MCLAREN TRAFFIC ENGINEERING

14th October 2020

Reference: 200379.02FB

LETTER OF RESPONSE REGARDING MIXED USE DEVELOPMENT AT 4 - 18 NORTHWOOD ROAD & 274 - 274A LONGUEVILLE ROAD, LANE COVE

FIGURE 1: POISSON DISTRIBUTION

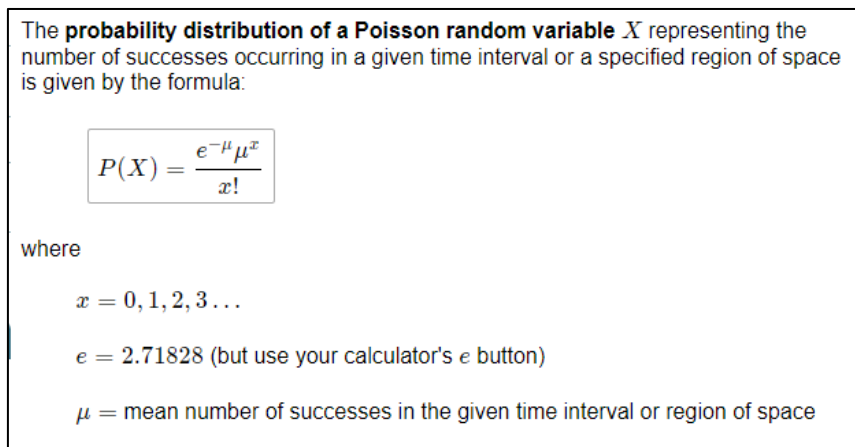
A safety and functionality report for the traffic signals for the one-way ramp has been asked for

MTE Response: A queuing assessment has been undertaken to determine the queue impacts as a result of the single lane ramp. The following are relevant to note:

- The basement serving the single lane ramp will be restricted to staff parking only;
- It will be assumed to be conservative that all spaces will generate 1 vehicle trip in a single peak hour (highly conservative) resulting in a traffic generation of 44 vehicle trips
- The inbound and outbound distribution from the car park will follow that of typical office development being the following:
 - AM peak hour period – 90% inbound (40), 10% outbound (4);
 - PM peak hour period – 10% inbound (4), 90% outbound (40).

As noted above, staff development traffic is highly tidal as such to determine any sort of queuing that may occur due to the single lane ramp, the probability of a vehicle exiting the Level 1 Basement and entering the Level 1 Basement needs to be determined. Outside this conflict there is no conflict between opposing vehicle streams, such that there would be no vehicle queues.

To determine the conflict of opposing vehicle streams, reference is made to the Poisson Distribution as shown in **Figure 1** below. Which allows the determination of an event occurring over a given time interval or a specified region of space, which in our case is the time it would take a vehicle to travel along the one-way section of ramp.

The above determination of conflict between opposing vehicle streams has been undertaken based upon the following considerations:

- A distance of 50m between passing opportunities (i.e. the distance where access is restricted to one vehicle);
- Based upon the 50m and a travel speed of 5km/h (highly conservative), the resulting time it takes to travel the 50m distance is 36 seconds;
- Adopting an addition factor of safety of 4 seconds for the light to turn from red to green or vice versa results in a travel time of 40 seconds;
- Inbound traffic of 40 vehicle trips;
- Outbound traffic of 4 vehicle trips.

Adopting the above time of conflict, vehicle trips and direction, the probability of conflict along the 50m length of assessed area is 3.52%. As shown, this is a low chance of conflict between vehicle streams, resulting in one conflict occurring every 28 AM peak hour period. When that conflict does occur, 92% of the time there would only be one vehicle waiting or 8% of the time there would be more than one vehicle waiting for the inbound traffic stream (40 vehicle trips). It should be noted that the 99th percentile queue is two (2) vehicles.

The above would also be the same during the PM peak hour period, but in the reverse direction, i.e. 4 inbound vehicle trips and 40 outbound (98th percentile queue of 2 vehicles when event occurs) vehicle trips.

Overall, the probability of the event occurring is low and the likelihood that there would be two (2) vehicles waiting due to the event would also be extremely rare. Considering this, the operation of the signals is deemed safe which will not have an adverse impact to other users of the car park.
